DOCKET NUMBER: 70-2946
APPLICANT: Louisiana Power and Light Company
FACILITY: Waterford Steam Electric Station, Unit 3
SUBJECT: SAFETY EVALUATION REPORT - Review of License Application Dated July 27, 1981, and Supplements Dated March 4, June 1, and 28, July 23, September 16, and December 13, 1982, and January 7, 20, and 24, 1983, for a Materials License

General

FIGURE - 1

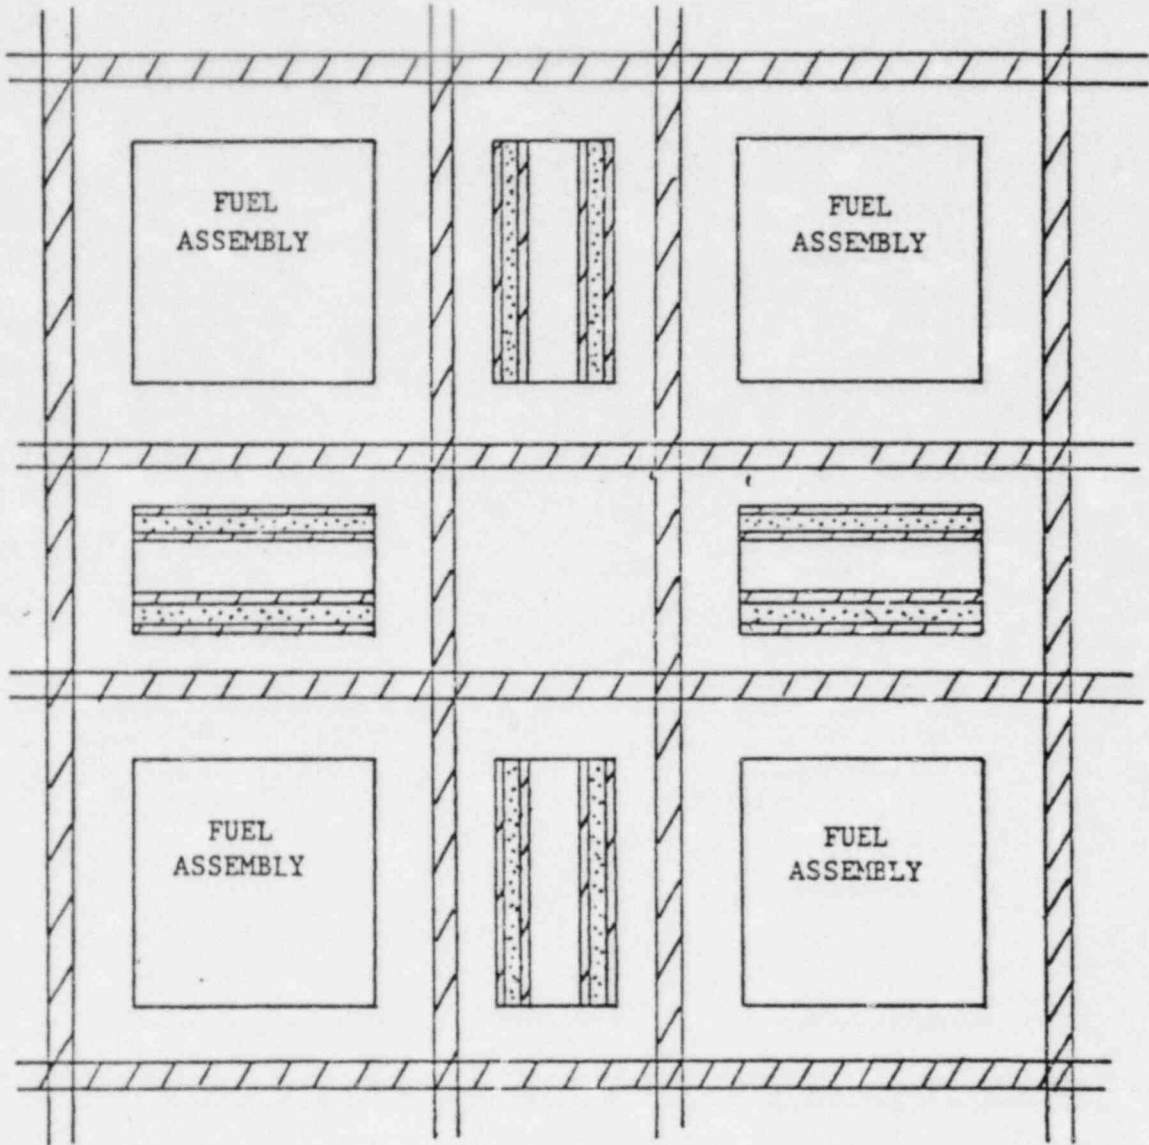
array, the applicant proposes to use a boron poison in the form of Boraflex,¹ encased in steel, between each assembly. Figure 1 shows the proposed spent fuel storage rack design. The NRC staff calculated a maximum k_{eff} for an infinite Boraflex-poisoned array to be 0.914 ± 0.004 under optimum conditions of water moderation. This value is in close agreement with that calculated by the applicant (0.905) under the same moderator conditions.

The applicant has attempted to show that the Boraflex poison is in place by a 15% random sampling program; however, because the presence of the poison is important to nuclear criticality safety the staff feels that the sampling program is inadequate. Accordingly, it is recommended Condition 17 be added to the license to require the applicant to confirm the presence of the Boraflex in all design locations in the spent fuel storage pool storage rack array before fuel assemblies can be stored in adjacent cells. Until the confirmatory tests have been completed, the applicant requests authorization to store the fuel assemblies in alternate rows and columns in the spent fuel pool storage racks. This would position the fuel assemblies on 20.5-inch centers. In the absence of Boraflex, an array of assemblies at this spacing is safe in the spent fuel pool storage racks under optimum conditions of water moderation and reflection. Condition 17 also permits the applicant to store the fuel assemblies on 20.5-inch centers until satisfactory completion of the Boraflex testing.

17. The applicant shall confirm the presence of the Boraflex in all design locations in the spent fuel pool rack array prior to storing fresh fuel in adjacent cells in the racks in the spent fuel pool. The spent fuel storage racks may be used prior to satisfactory completion of the confirmatory tests, providing fresh fuel assemblies are stored only in alternate rows and columns in the racks on a center-to-center spacing between fuel assemblies of at least 20.5-inches.
